ADDENDUM NO. 1

Date: **February 9, 2024**
Issued by: **Sacramento City Unified School District**
Project: **Project #0410-409-1 Albert Einstein MS Modernization**

DATE 06/19/2023
 JOB NO. Y2243.00
 SHEET TITLE
GRADING PLAN
 SHEET NO.
C2.2

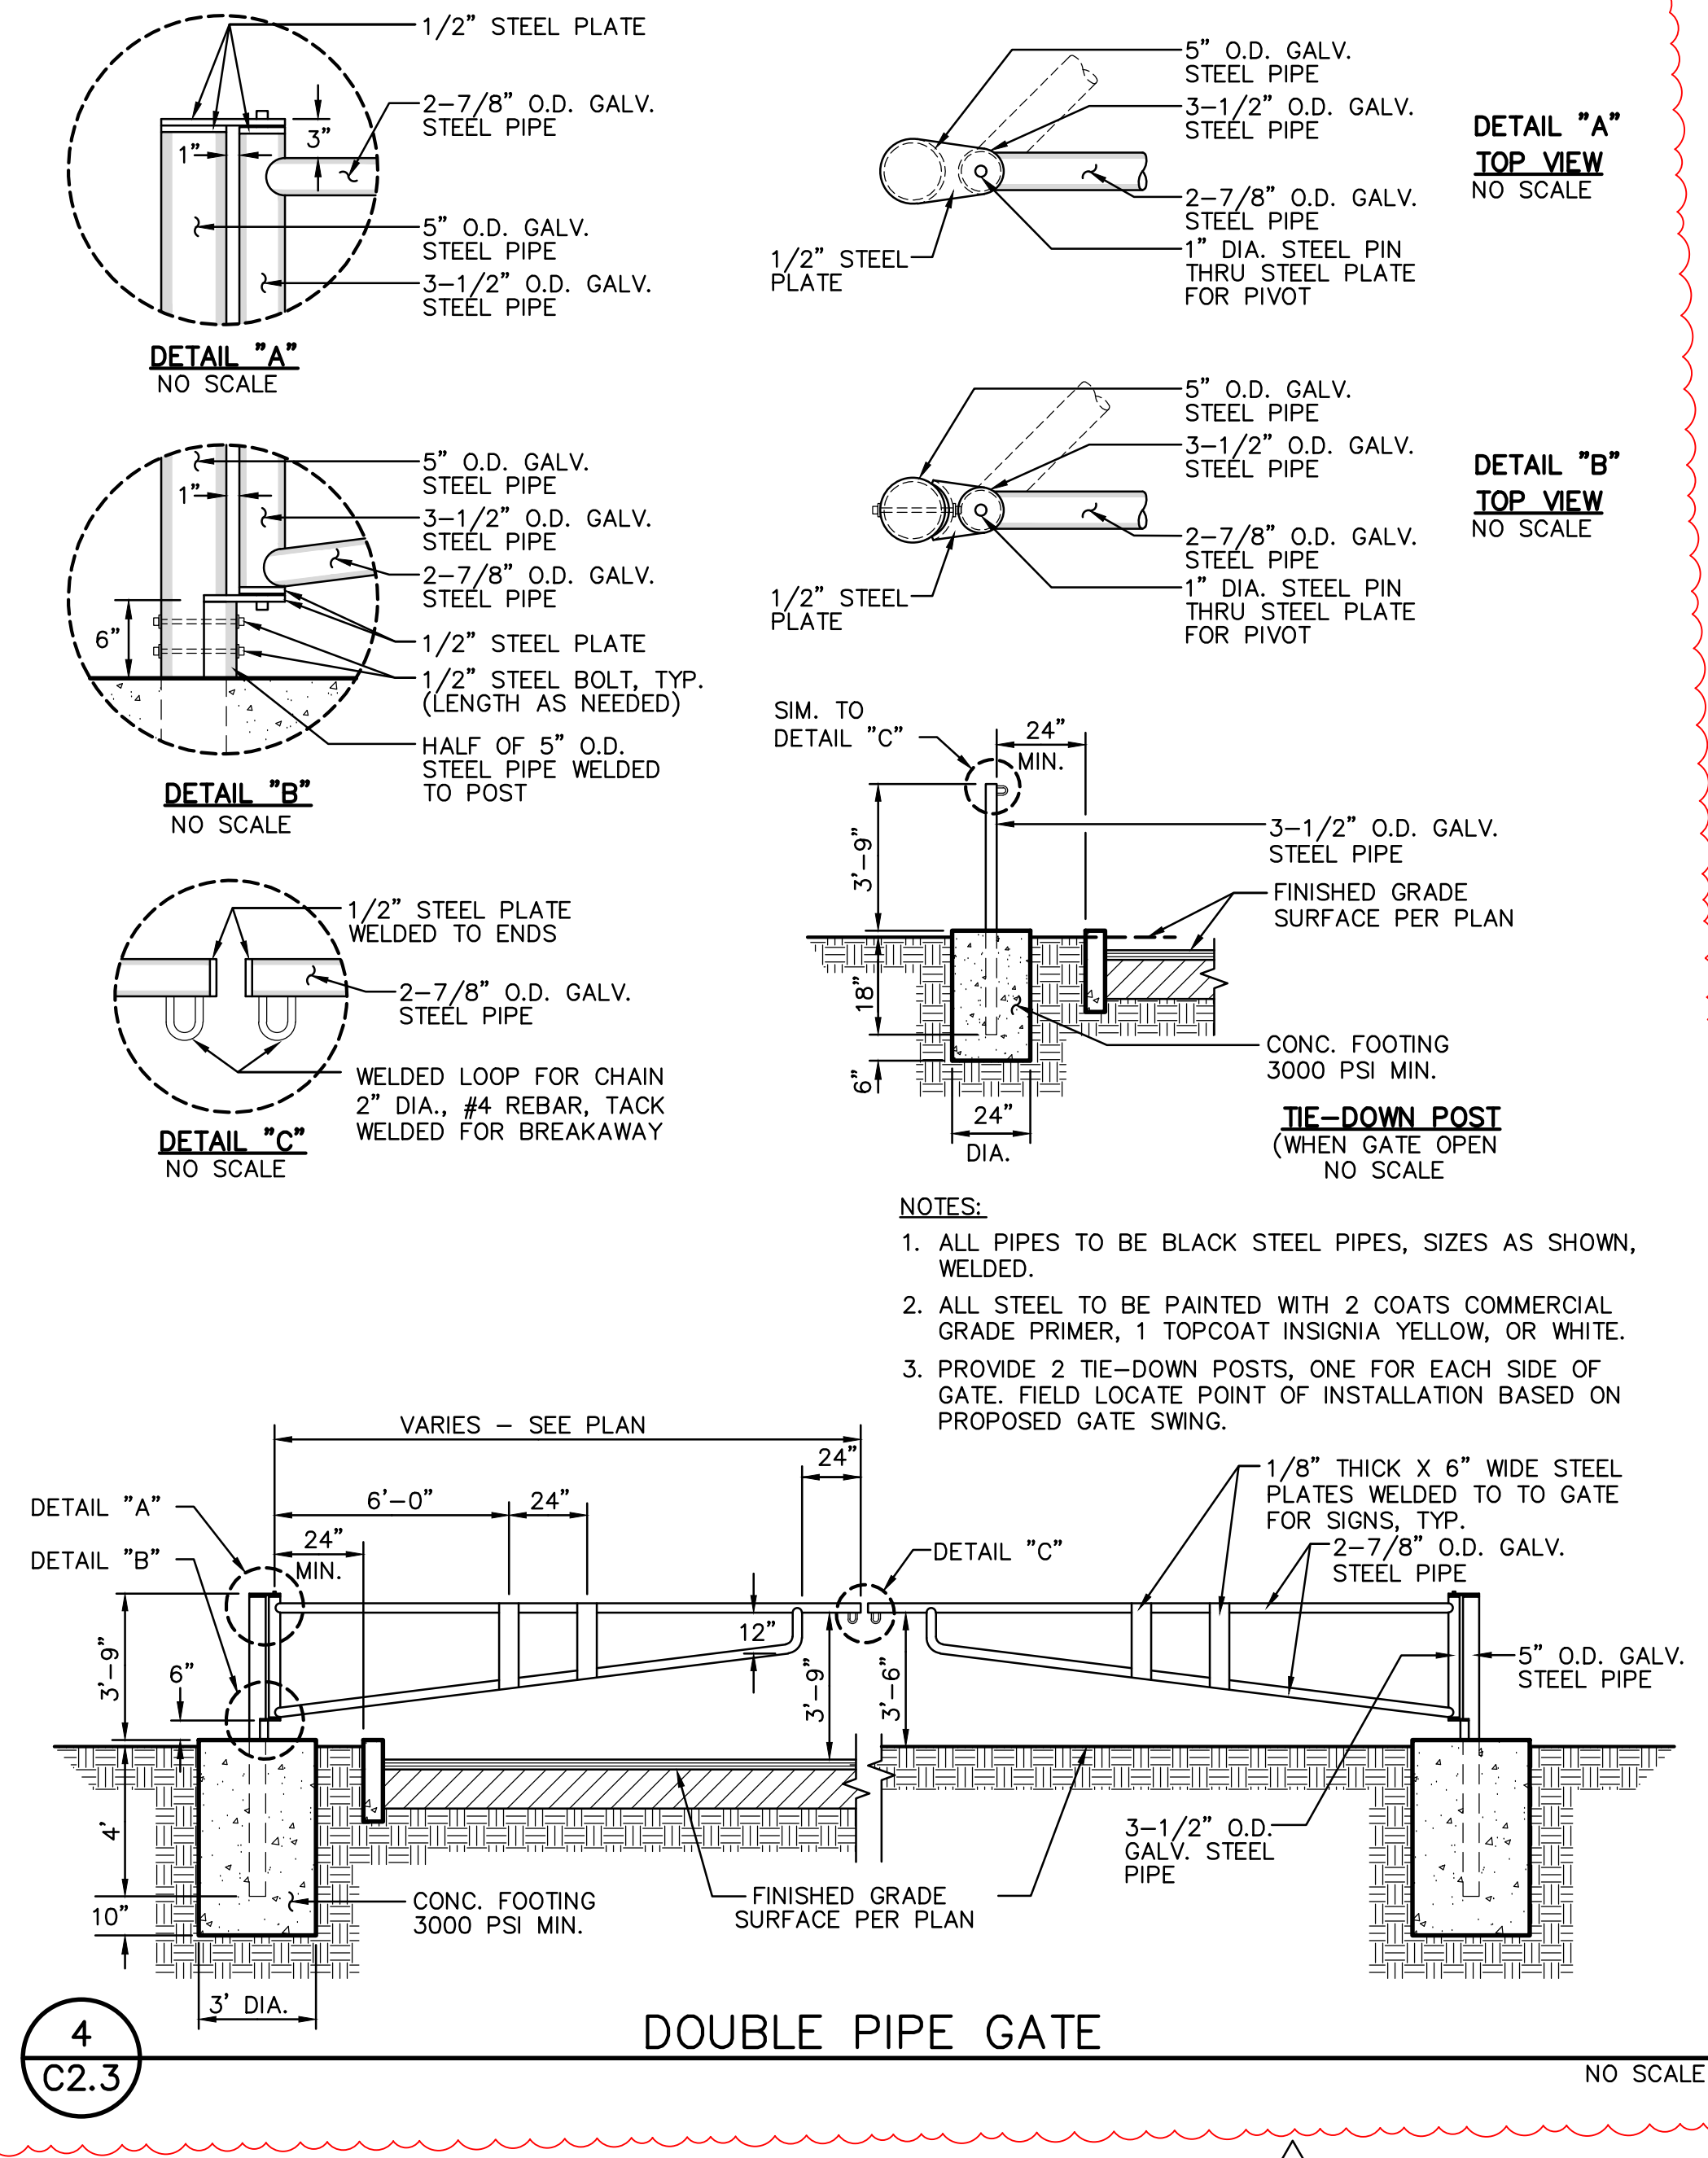
Addendum Item No. AD1.05- C2.2 Grading Plan (Package A)

- Replace sheet in its entirety per addendum drawing number AD01.05. Pipe gates added at drive entrances.

AD01.06
 PACKAGE A
 02/08/2024

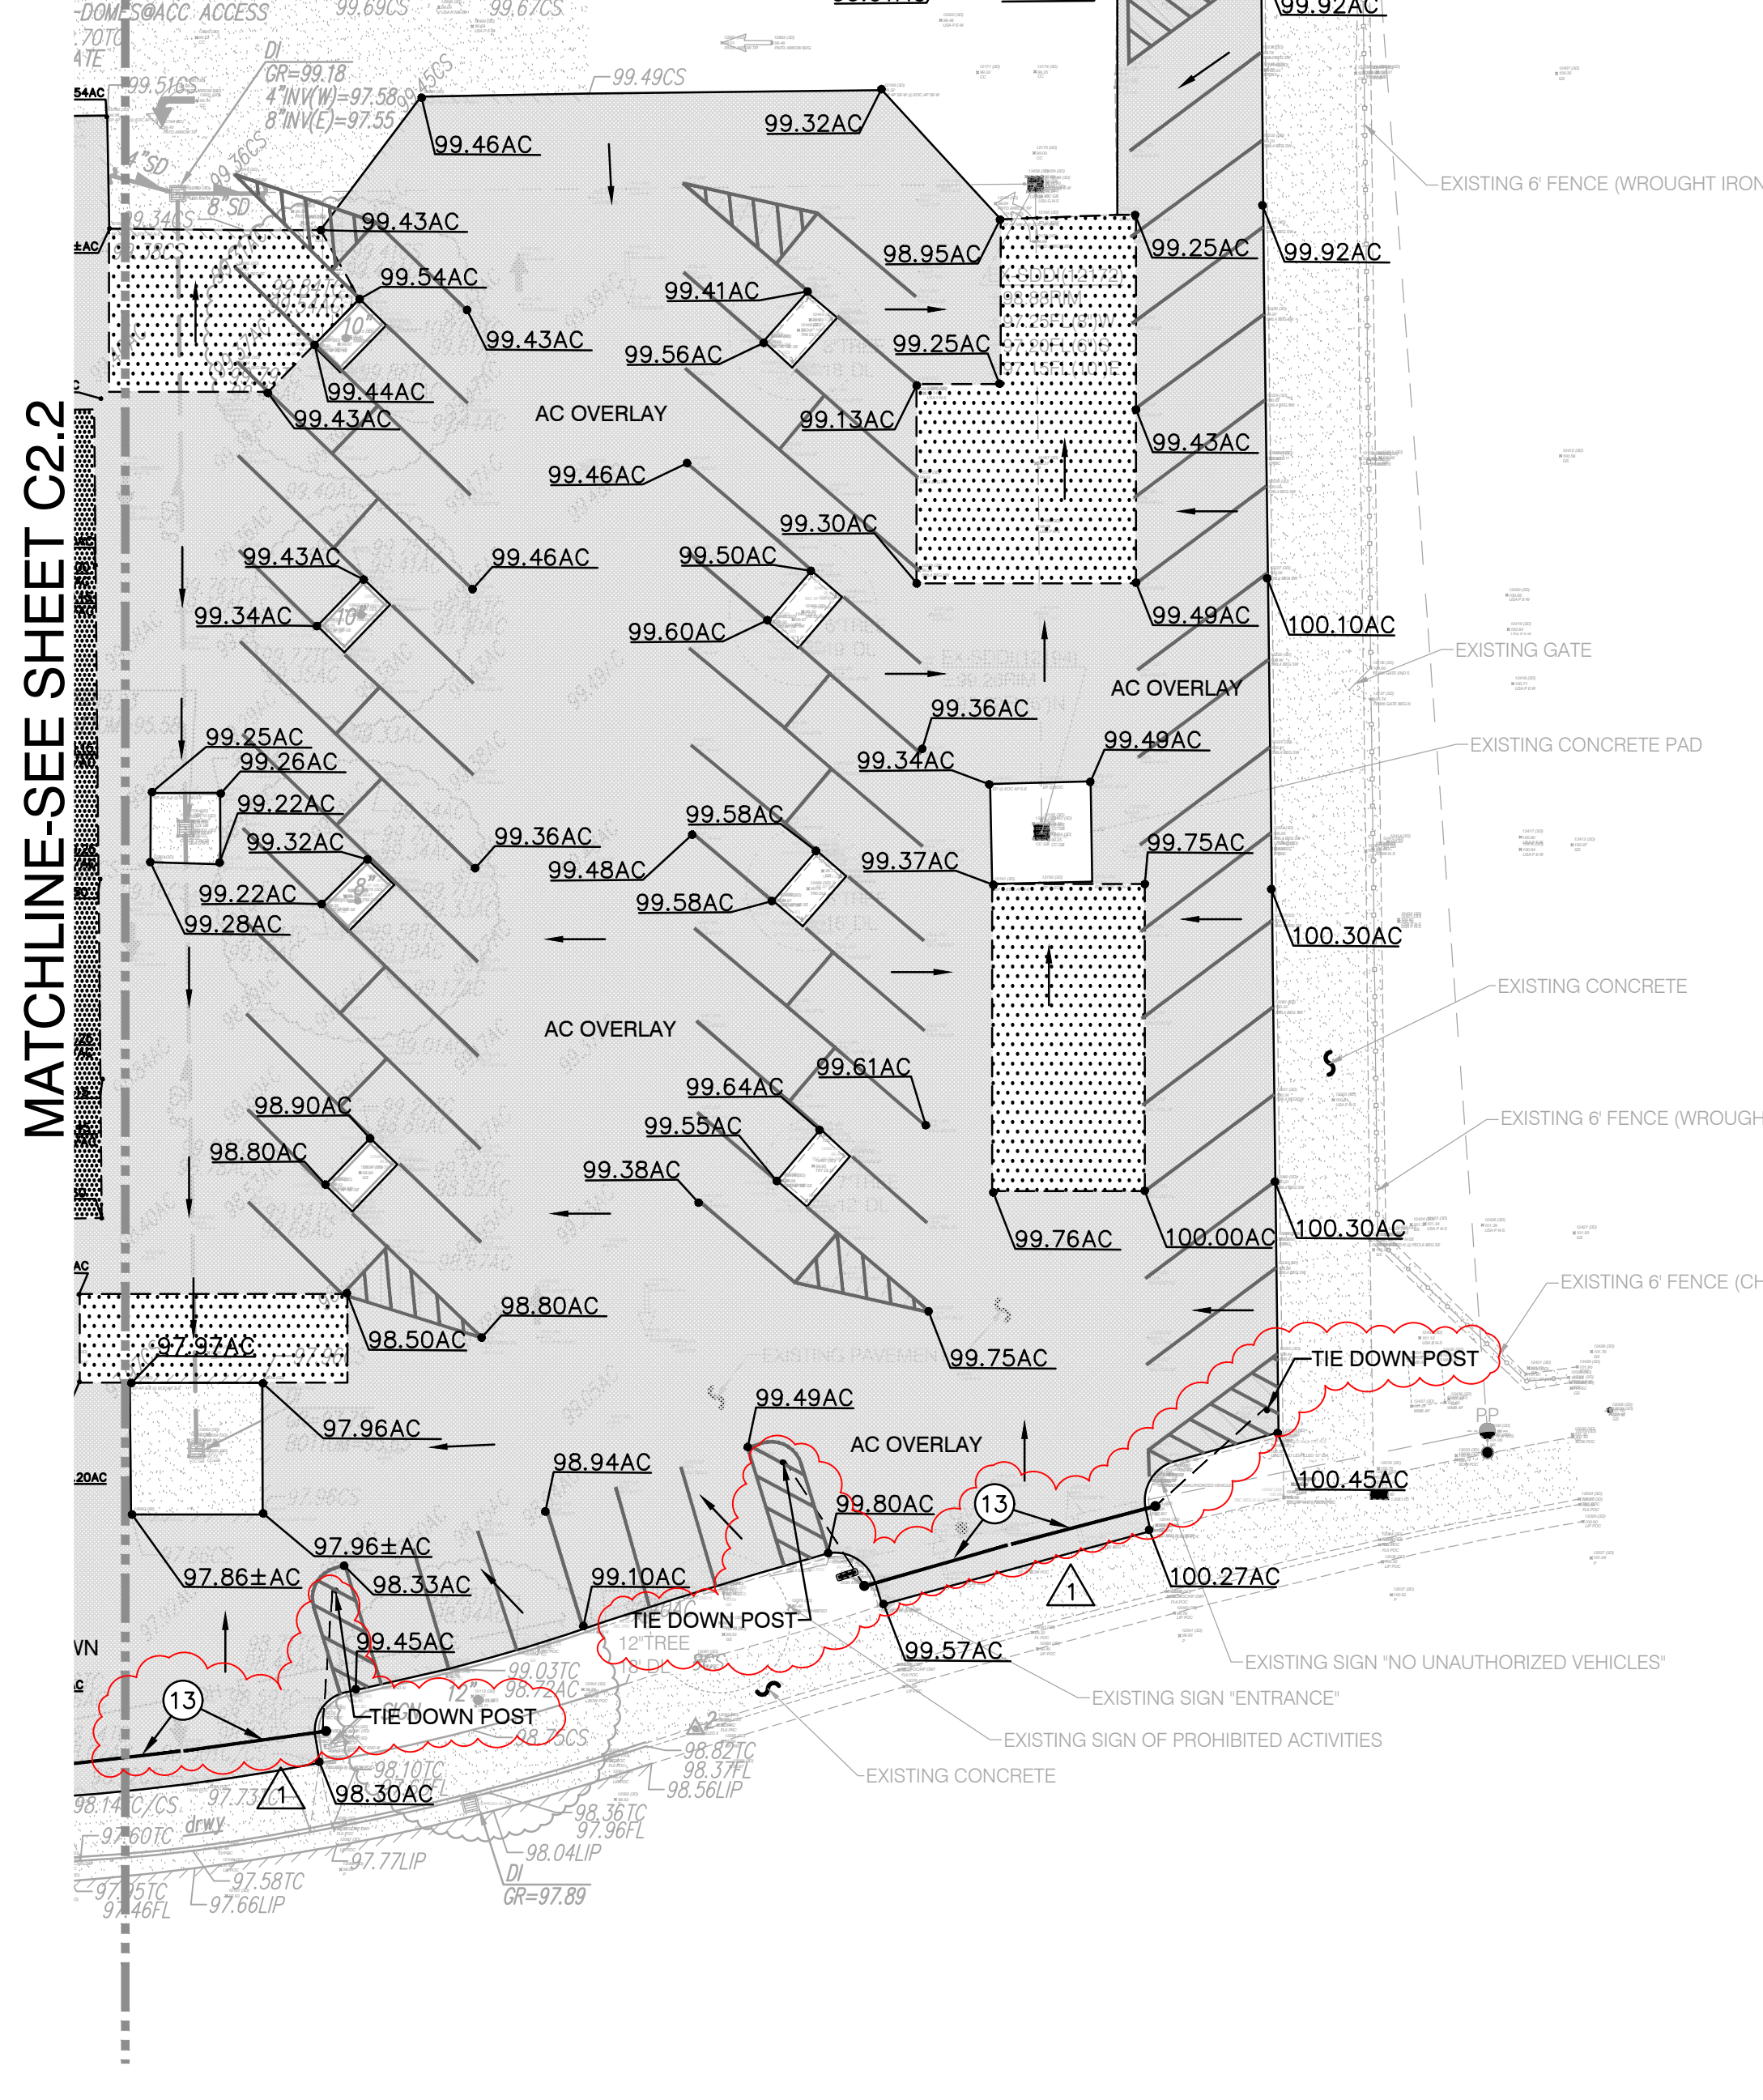
Addendum Item No. AD1.06- C2.3 Grading Plan (Package A)

- Replace sheet in its entirety per addendum drawing number AD01.06. Pipe gates added at drive entrances.

PAVING AND STRIPING PLAN

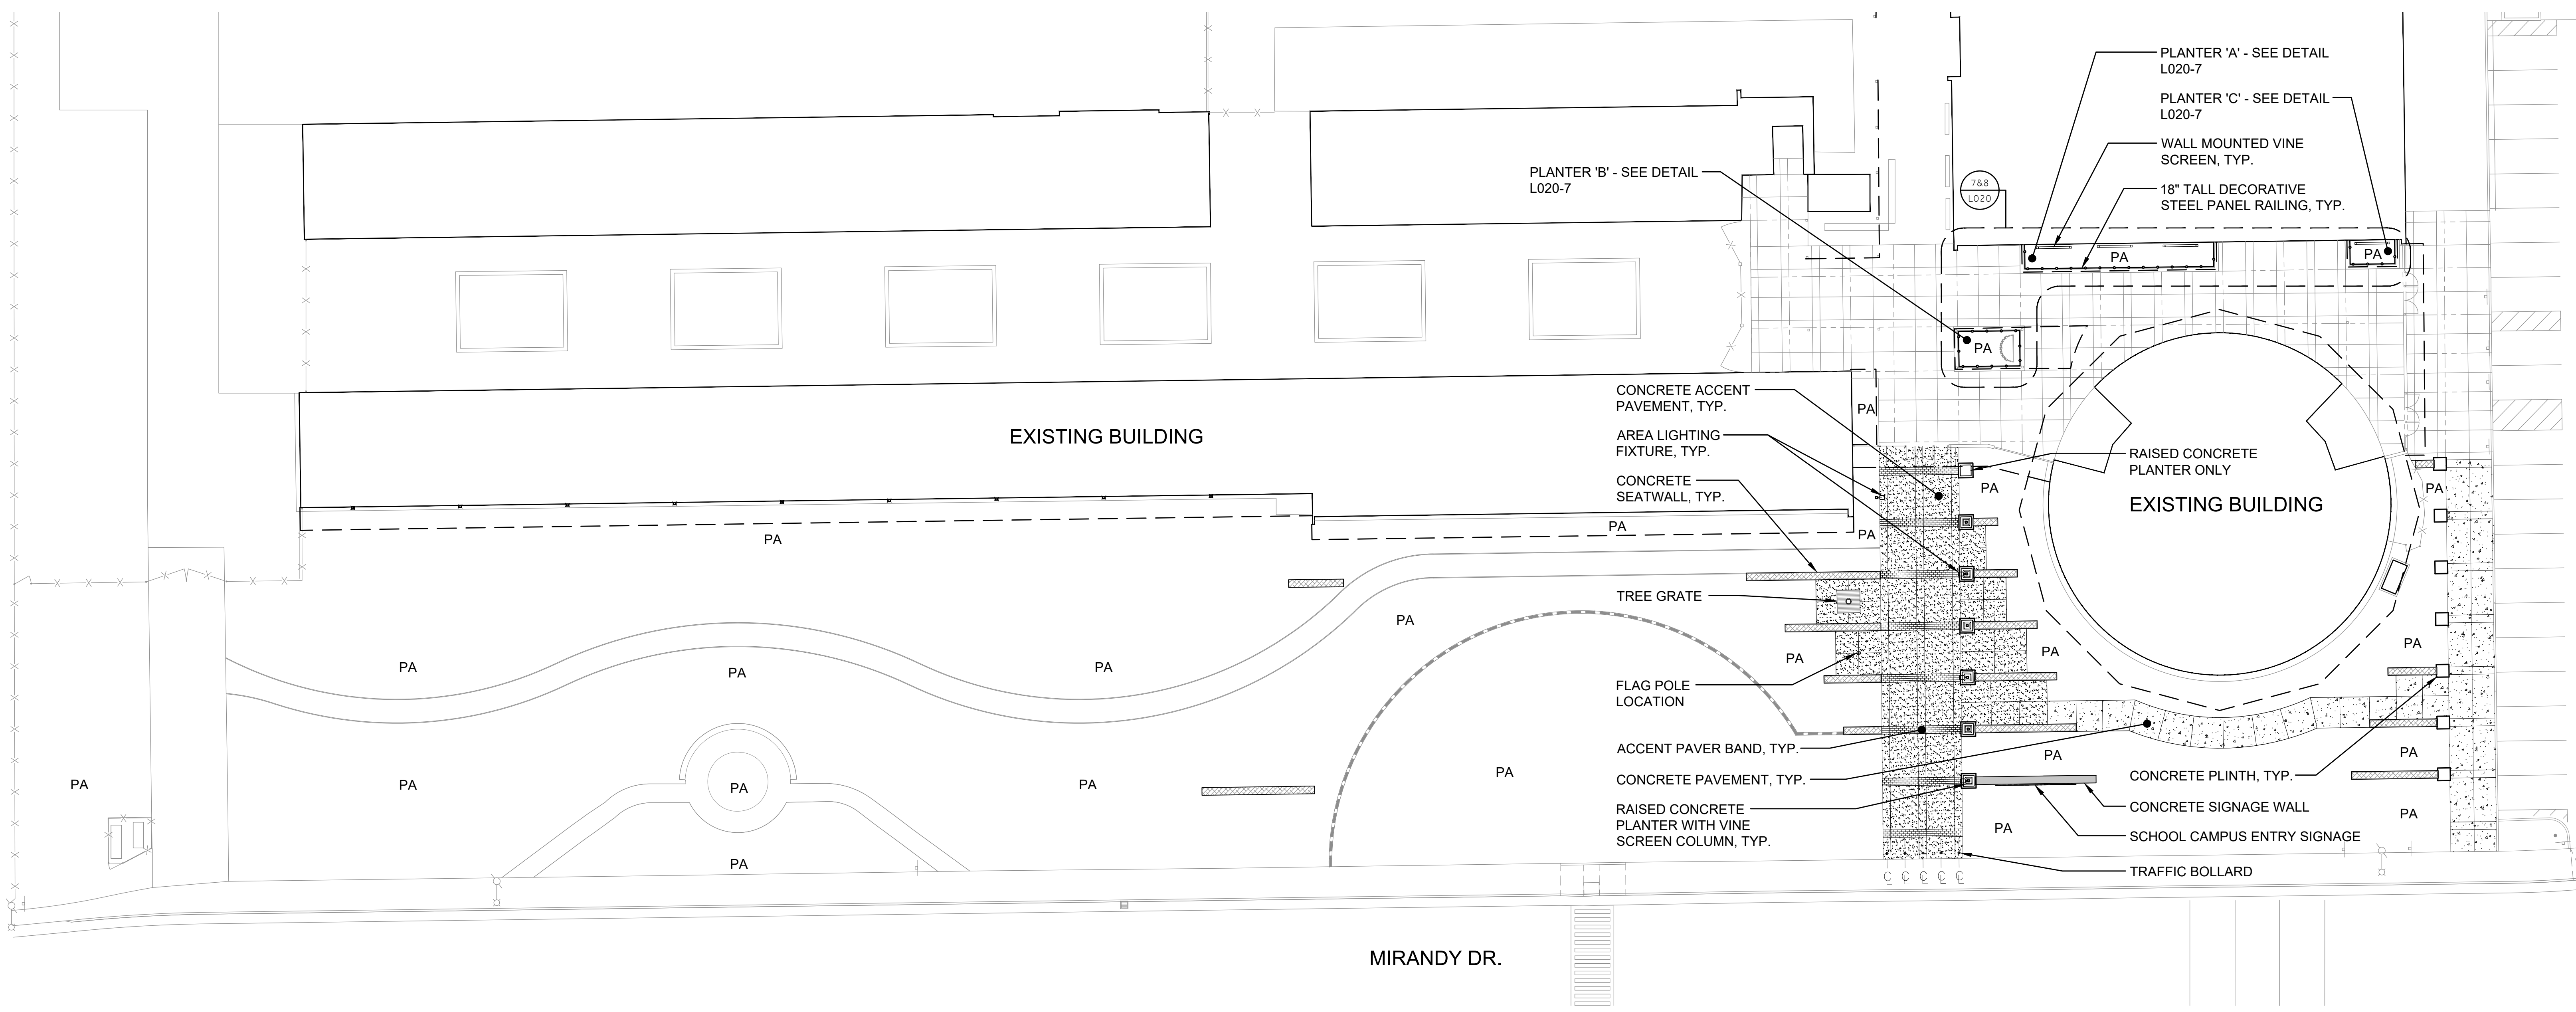
Addendum Item No. AD1.07- C4.3 Paving and Striping Plan (Package A)

- Replace sheet in its entirety per addendum drawing number AD01.07. Pipe gate striping added at drive entrances.
